Reference: Hanford Waste Vitrification Plant
DOE Contract DE-AC06-86RL10838
Fluor Contract 8457

US DEPARTMENT OF ENERGY
HANFORD WASTE VITRIFICATION PLANT

DESIGN CHANGE NOTICE

DCN TITLE: Hold on A/G Pwr & Gndg for PX-500-001A/B and add Firewater Pump Alarm System

ELEMENTARY DIAGRAM 21
FOR PX-500-002A REMOTE OUTPUTS 122083

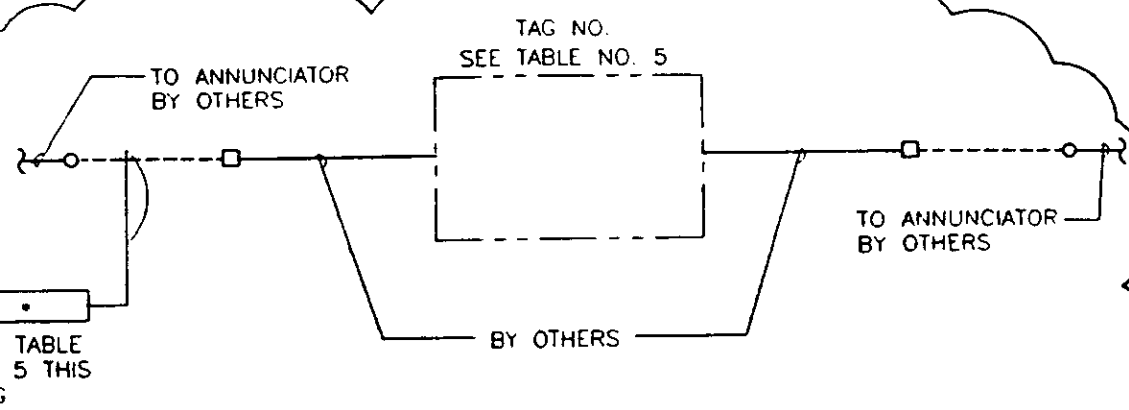
TABLE NO. 5		
TAG NO.	DESCRIPTION	CABLE NO. * (2/C)
XL-FWX-***B	PUMP PX-500-002A RUNNING	A0912
	PUMP PX-500-002A CONTROLLER PWR AVAILABLE	A0913
	PUMP PX-500-002A PHASE REVERSAL	A0914
ZAL-FWX-017-1B	PUMP PX-500-002A DISCHARGE VALVE NOT FULLY OPEN	A0915
ZAL-FWX-012-1B	PUMP PX-500-002A SUCTION VALVE NOT FULLY OPEN	A0916
PAL-FWX-005B	LOW FIRE WATER HEADER PRESSURE	A0917

ELEMENTARY DIAGRAM 25

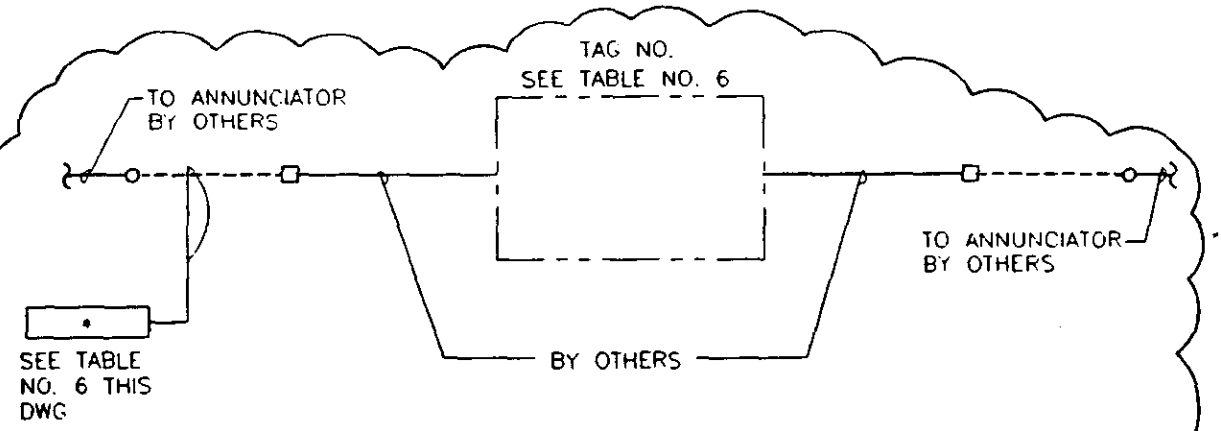
TABLE NO. 6		
TAG NO.	DESCRIPTION	CABLE NO. • (2/C)
XL-FWX-•••B	PUMP PX-500-002B RUNNING	A0918
	PUMP PX-500-002B CONTROLLER PWR AVAILABLE	A0919
	PUMP PX-500-002B PHASE REVERSAL	A0920
ZAL-FWX-017-2B	PUMP PX-500-002B DISCHARGE VALVE NOT FULLY OPEN	A0921
ZAL-FWX-012-2B	PUMP PX-500-002B SUCTION VALVE NOT FULLY OPEN	A0922
TALL-FWX-005B	FIRE & PROCESS WATER STORAGE TANK LEVEL	A0923

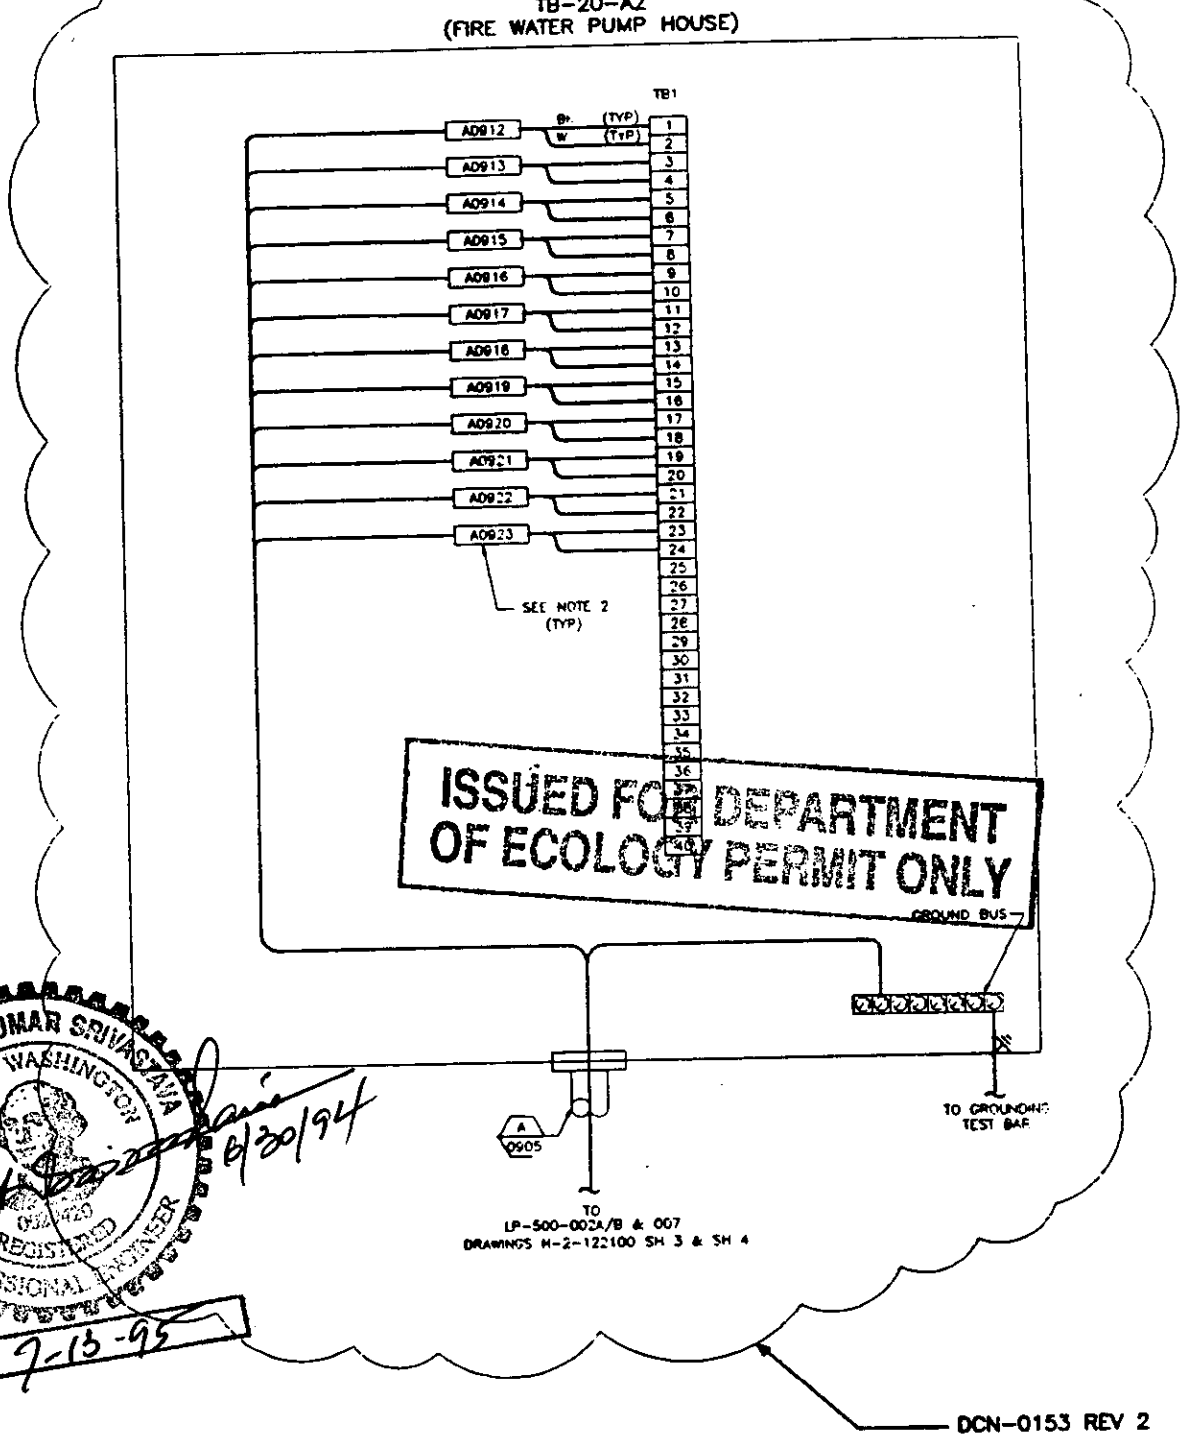
DOCUMENT NUMBER	SHT/ PAGE	REV NO	DOCUMENT NAME	INCLD Y/N	DESCRIPTION OF CHANGE
H-2-122082	5	0	Electrical Standard Details	Y	Added Detail G33
H-2-122085	1	2	Electrical U/G Conduit and Grounding Plan	Y	Added ground plate for grounding
H-2-122087	1	1	Instrument Conduit Routing Plan	Y	Added Conduits for Instruments REV. 2 CHANGE
H-2-122087	2	1	Instrument Conduit Routing Plan	Y	Added Conduits for Instruments and placed Hold No. 450
H-2-122089	1	3	Electrical Pwr, Gndg, Ht Tr and Ltng Protection Plan	Y	Placed Hold No. 450 and added heat tracing
H-2-122094	1	1	Pwr. Ltg. & Heat Tracing Sections & Details	Y	Added spare conduits. REV. 1 CHANGE
H-2-122098	1	2	Electrical Panel Schedule	Y	Revised panel schedule for heat tracing
H-2-122099	1	2	Electrical Elementary Diagram	Y	Added elementary diagrams for PX-500-002A
H-2-122099	2	1	Electrical Elementary Diagram	Y	Added elementary diagrams for PX-500-002B
H-2-122100	1	1	ELECTRICAL CONNECTION DIAGRAMS	Y	ADDED TERMINAL BOX WIRING DIAGRAM

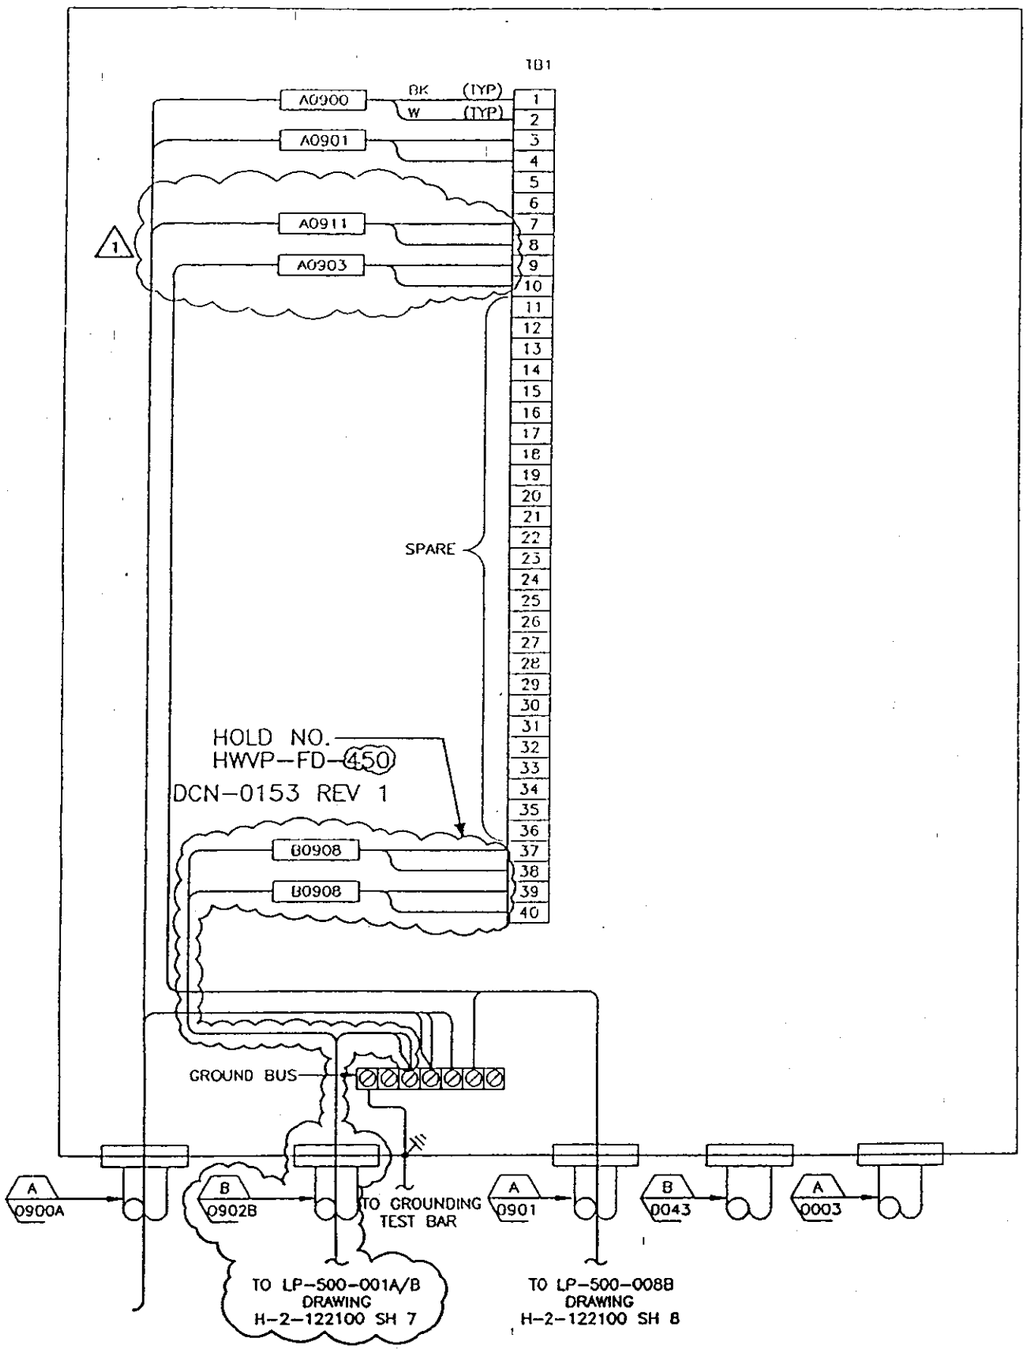
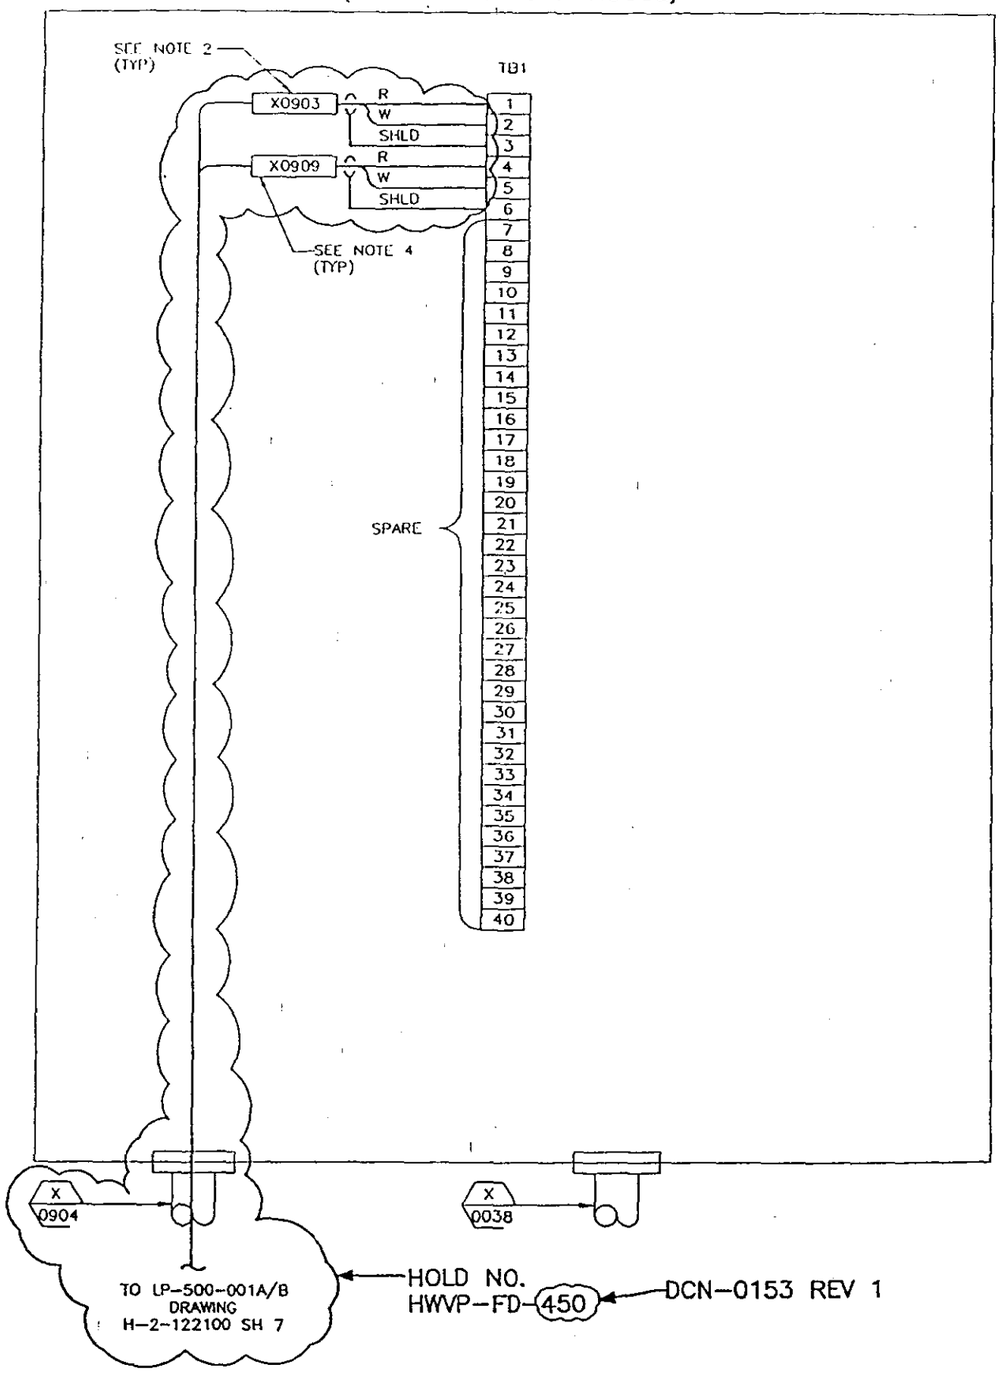
H-2-122100	2	1	Electrical Connection Diagrams	Y	Placed Hold No. 450
H-2-122100	3	0	Electrical Connection Diagrams	Y	Added instrument cable
H-2-122100	4	0	Electrical Connection Diagrams	Y	Added instrument cable
H-2-122100	7	0	Electrical Connection Diagrams	Y	Placed Hold No. 450 REV. 1 CHANGE
Specification B-595-C-A160-16111 Attachment A	1, 6, 7, 9, 10, 11, 17	2	Conduit Schedule	Y	Added conduit for instruments and placed Hold No. 450 Revised designations on P. 17

FRONT OF PANEL LAYOUT

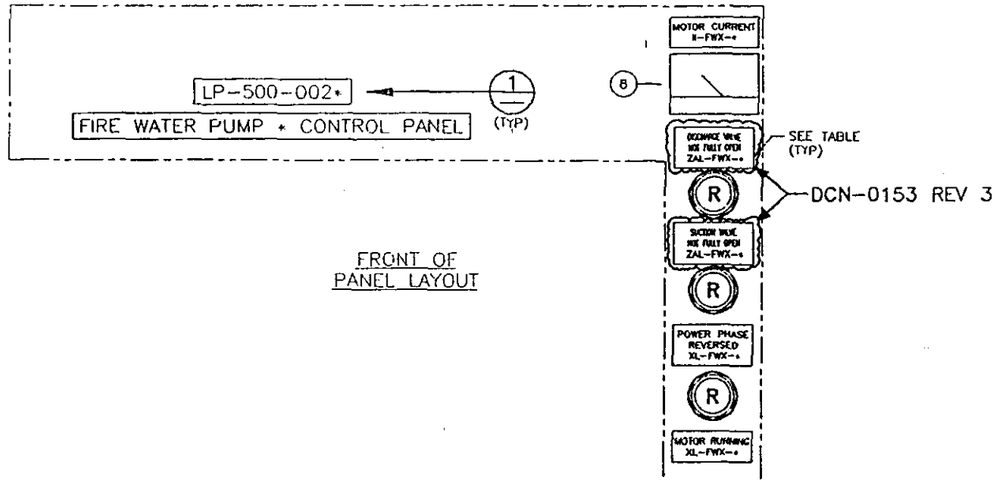
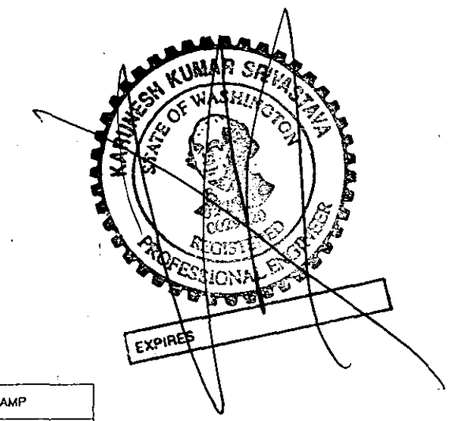
B-595-C-A160-15540	11	1	FIREWATER SYSTEM PUMPS	Y	REVISED PARA. 2.2.10.B
B-595-C-A160-15540	12	1	FIREWATER SYSTEM PUMPS	Y	REVISED PARA 2.2.10.B
H-2-121656	1	0	LP-500-002A & 002B INSTRUMENT PANEL LAYOUT	Y	REVISED NAMEPLATE INSCRIPTIONS
